## HISTORIC AND DESIGN REVIEW COMMISSION

**HDRC CASE NO:** 2025-040  
**ADDRESS:** 501 E LOCUST  
**LEGAL DESCRIPTION:** NCB 1736 BLK 10 LOT 1  
**ZONING:** MF-33, H  
**CITY COUNCIL DIST.:** 1  
**DISTRICT:** Tobin Hill Historic District  
**APPLICANT:** Janelle Patrick/Rhino Design Build, LLC  
**OWNER:** Shane Wohlrabe/WOHLRABE SHANE & IRENE  
**TYPE OF WORK:** Front porch modifications  
**APPLICATION RECEIVED:** February 17, 2025  
**60-DAY REVIEW:** April 18, 2025  
**CASE MANAGER:** Bryan Morales  
**REQUEST:**

The applicant is requesting a Certificate of Appropriateness for approval to replace the porch roof with a new porch roof of similar design to include the increase of 1'6" in depth and two Tuscan-style columns to match an existing column onsite.

PROPOSED PORCH

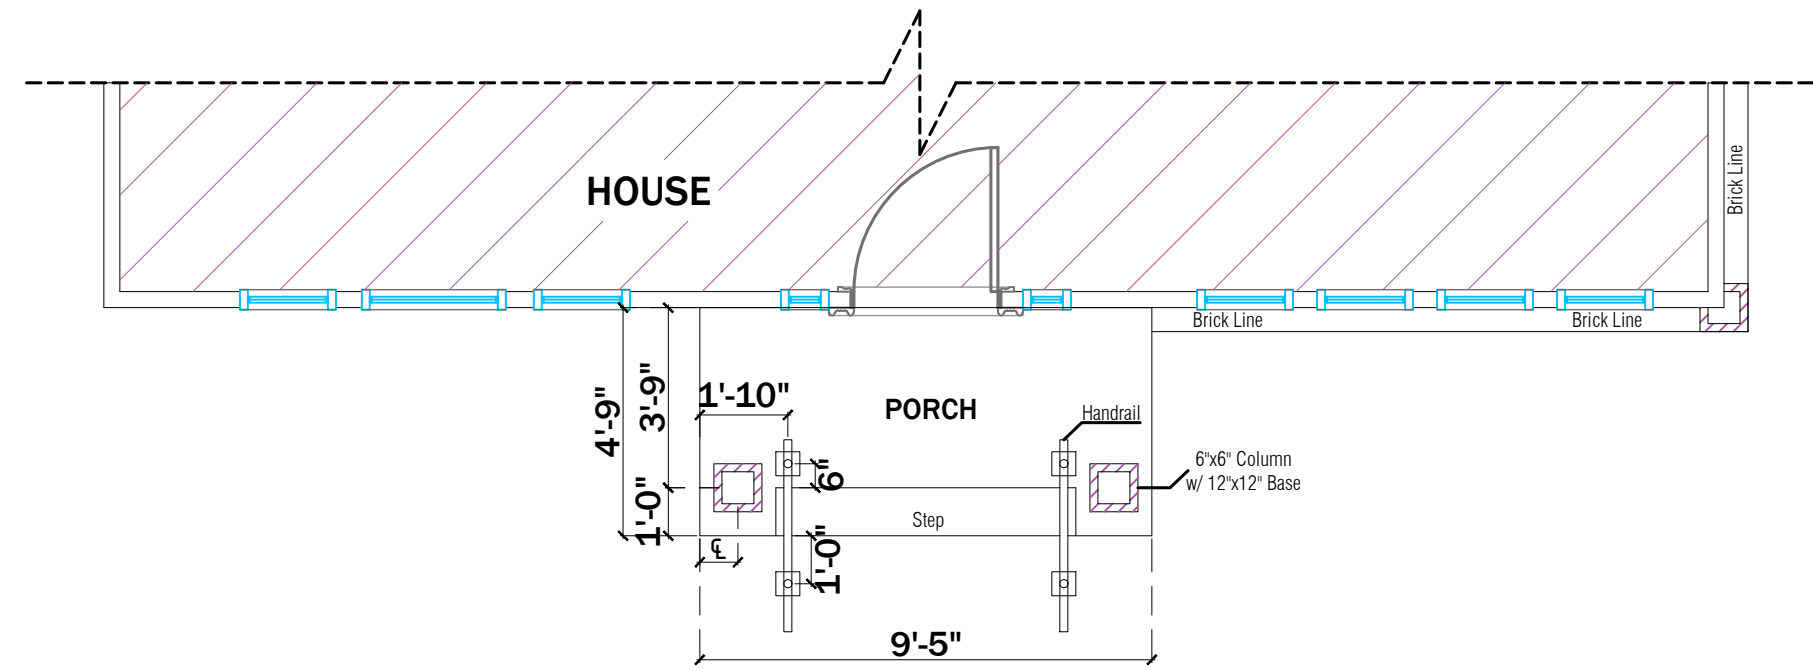
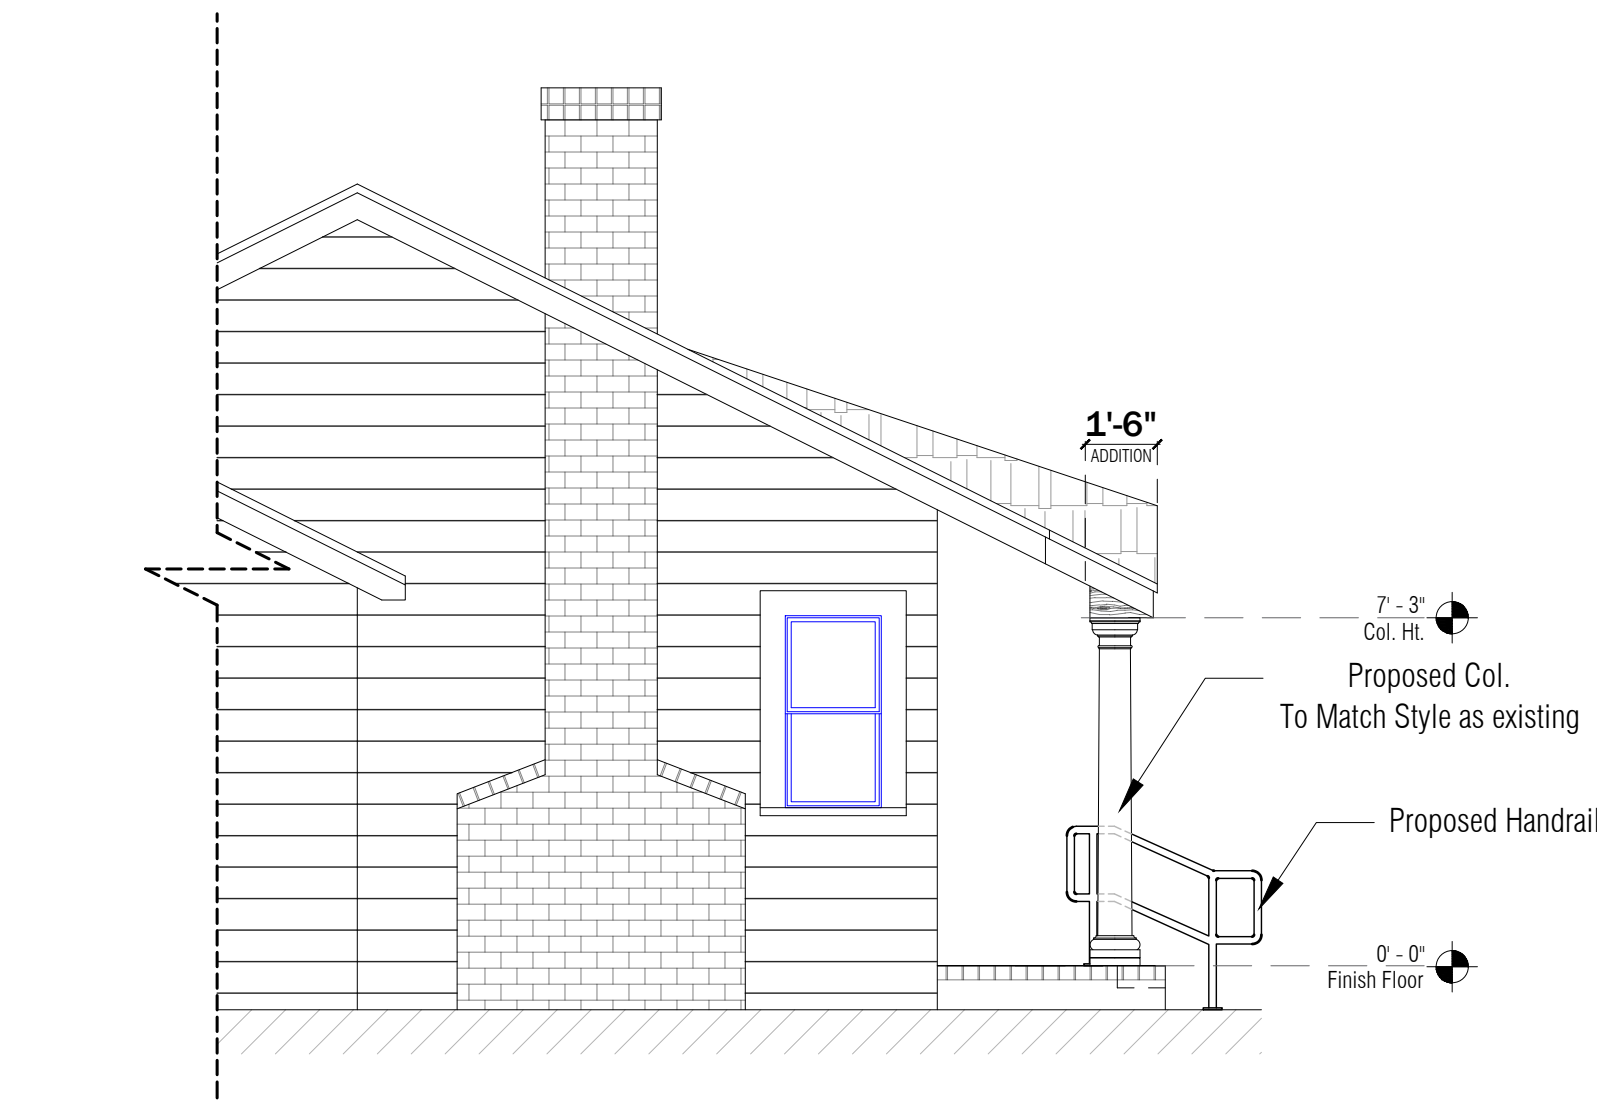
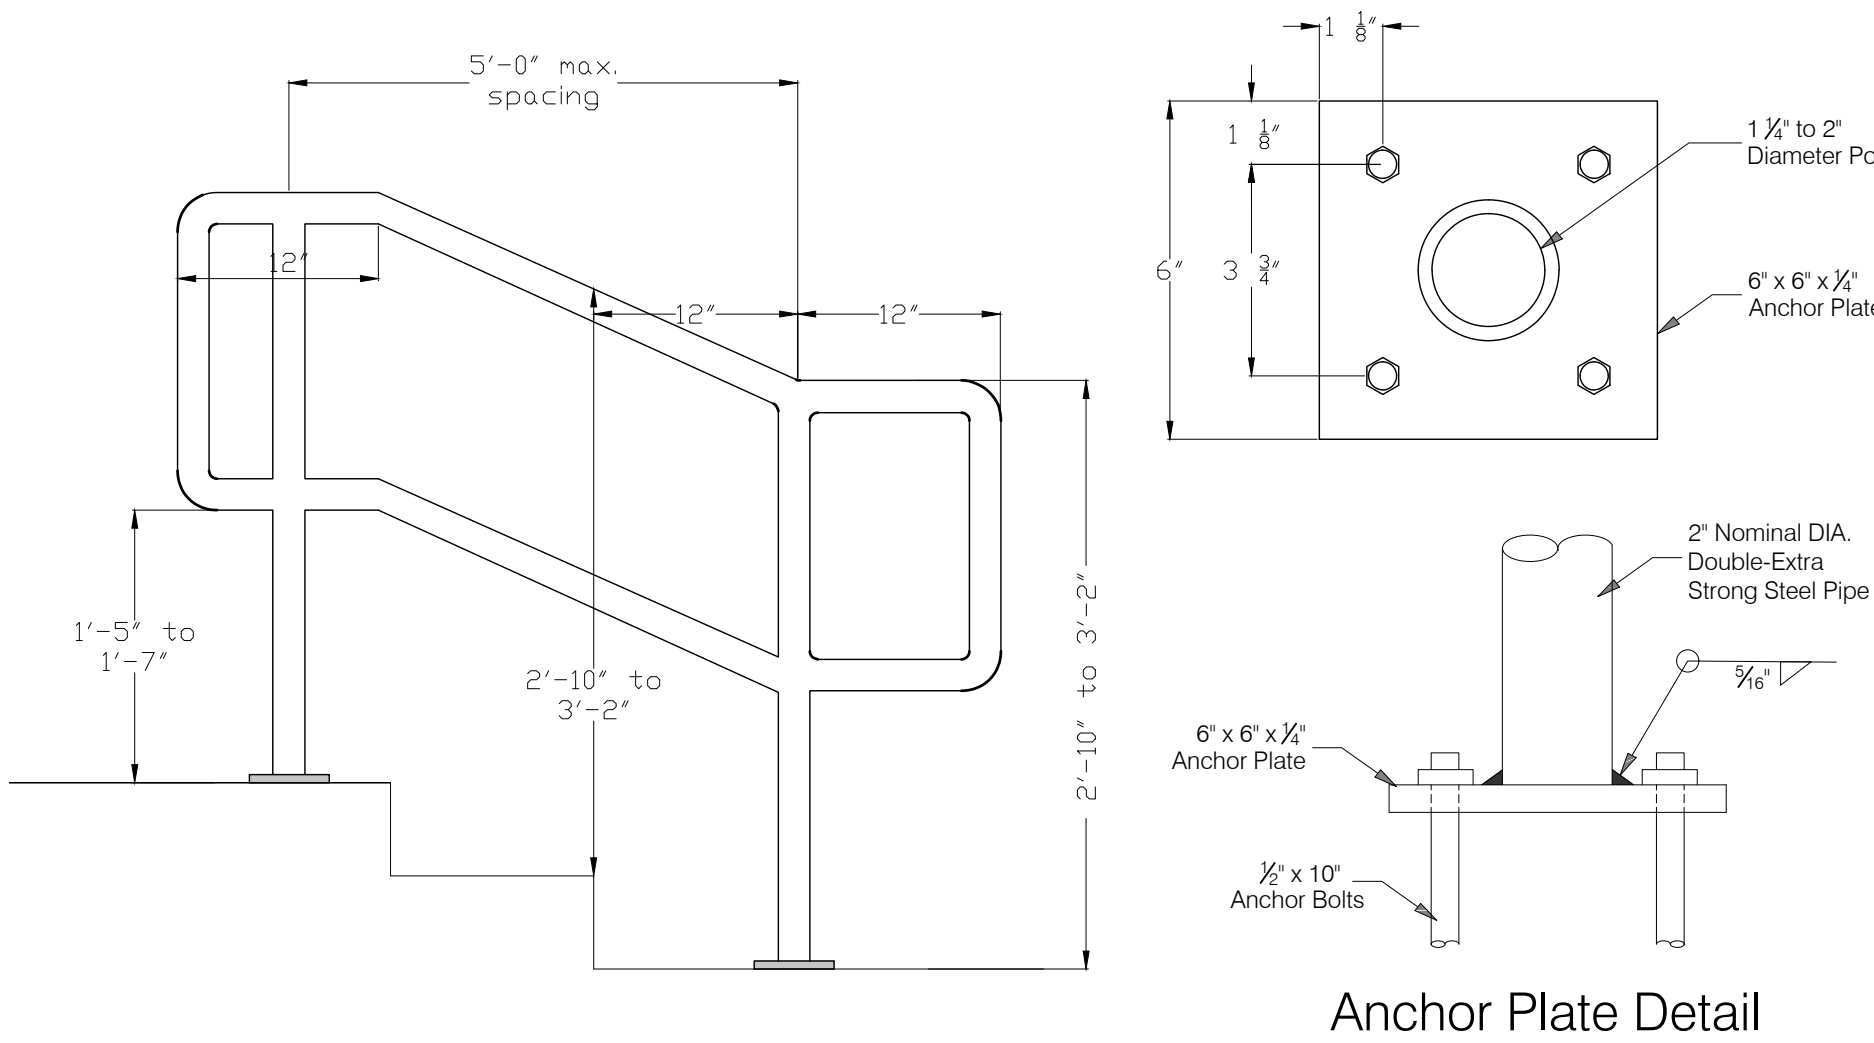
- c. **PORCH ROOF REPLACEMENT** – The applicant is requesting approval to replace the porch roof with a new porch roof of similar design to include the increase of 1'6" in depth and two Tuscan-style columns to match an existing column onsite. In the submitted application, the applicant has indicated an engineer found the existing porch roof is not structurally sound and has advised to rebuild the porch roof, increase the depth by 1'6", and install two support columns. The Historic Design Guidelines for Exterior Maintenance and Alterations 7.B.iii. states to replace in-kind porches and related elements in-kind when such features are deteriorated beyond repair. Additionally, the design should be simple as to not distract from the historic character of the building. Staff finds the porch roof replacement, increase in depth, and new columns generally appropriate.

Staff recommends approval of the request, based on findings a through c, as submitted.
